Notice of Allowability	Application No.	Applicant(s)	
	10/783,321	LIAO, JUEI-SENG	
	Examiner	Art Unit	
	Clark F. Dexter	3724

EXAMINER'S AMENDMENT

FIG. 4

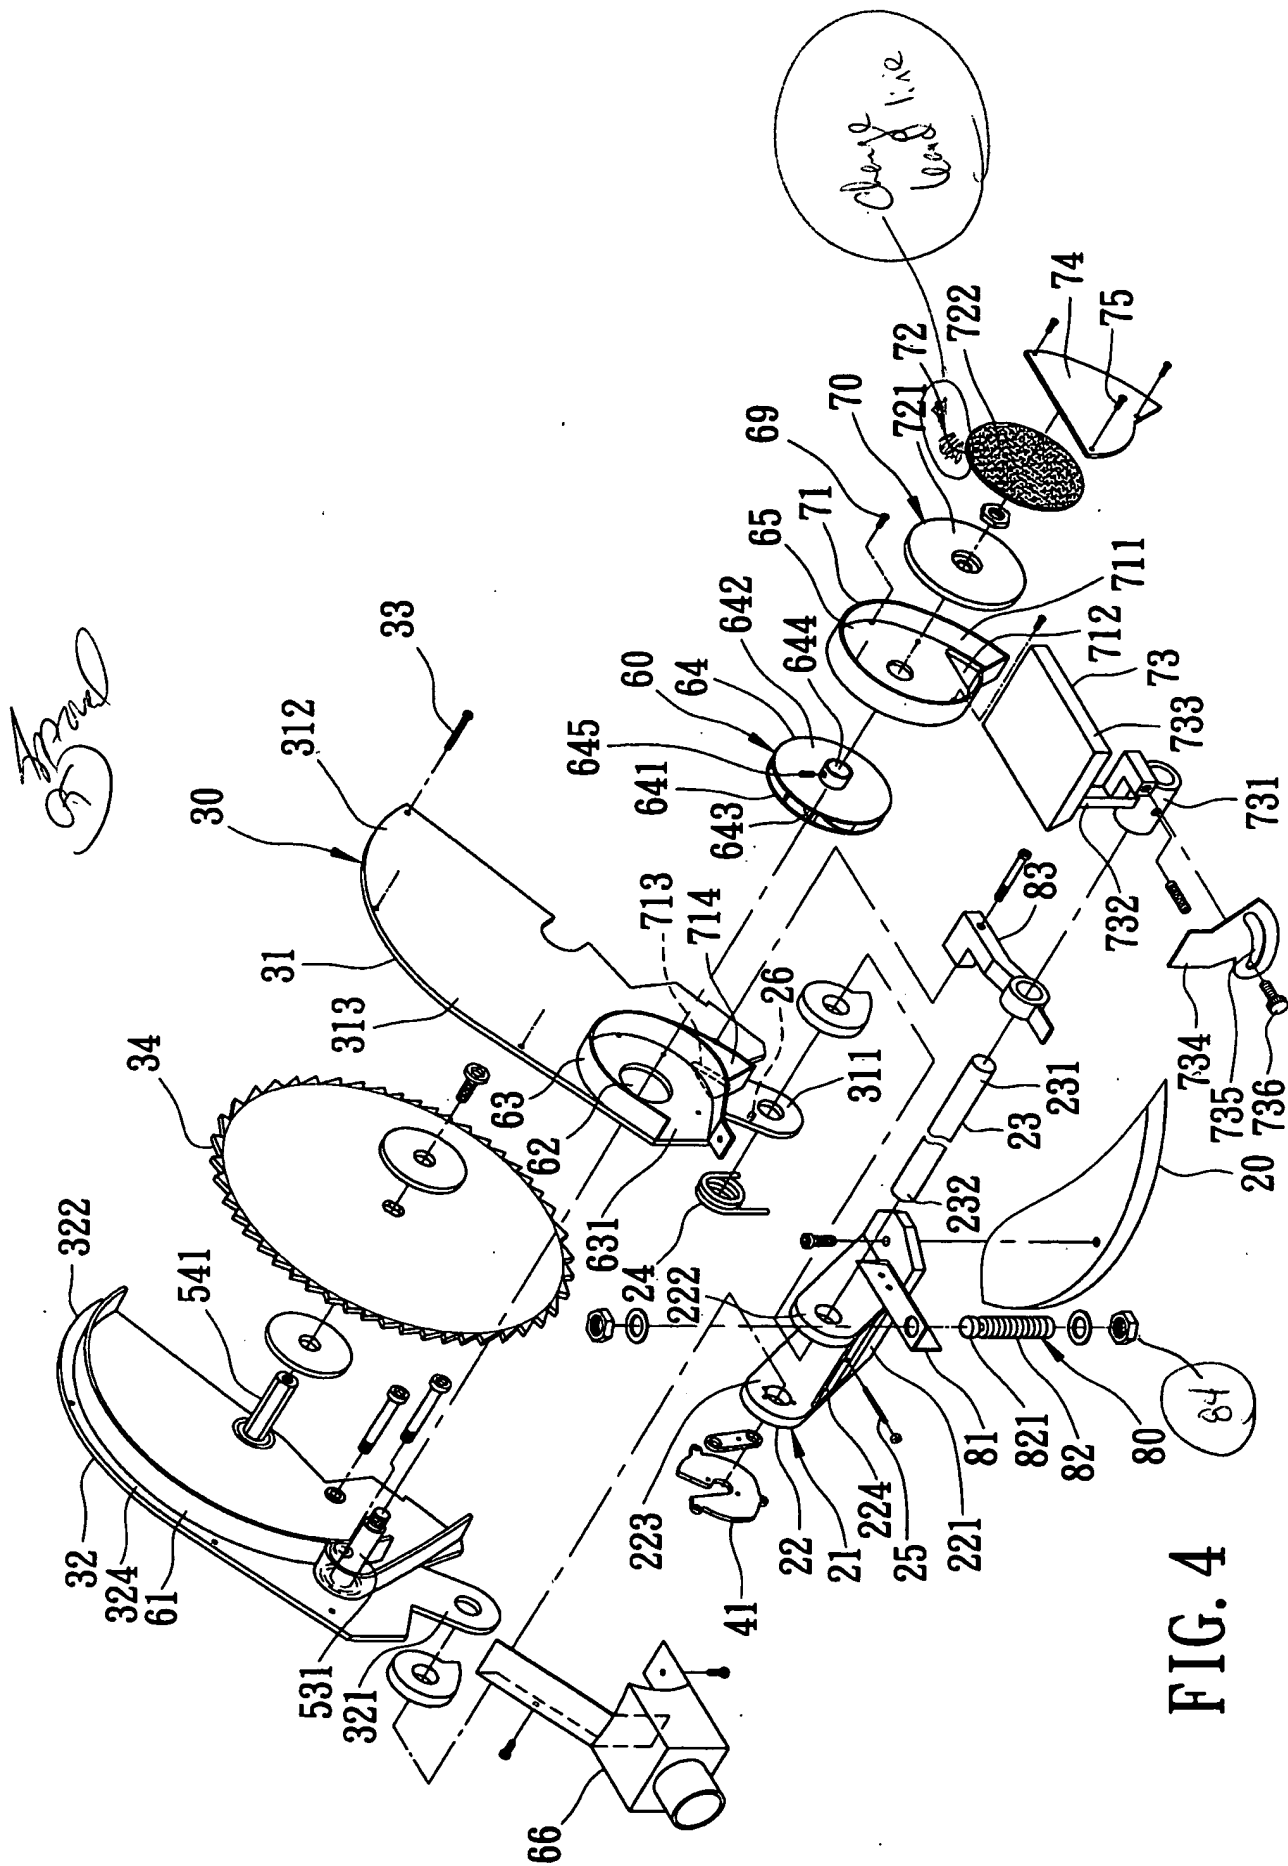
In Figure 4, numeral 84 should be added to indicate the fastener (located to the right of numeral 80) as described on page 11, line 15; for numeral 72, the current lead line should be replaced by an arrowheaded lead line such that numeral 72 indicates both the grinding wheel 721 and the sandpaper 722 as described on page 10, lines 4-12.

These changes are shown in the marked-up copy of Figure 4 included herewith and should be made by applicant.
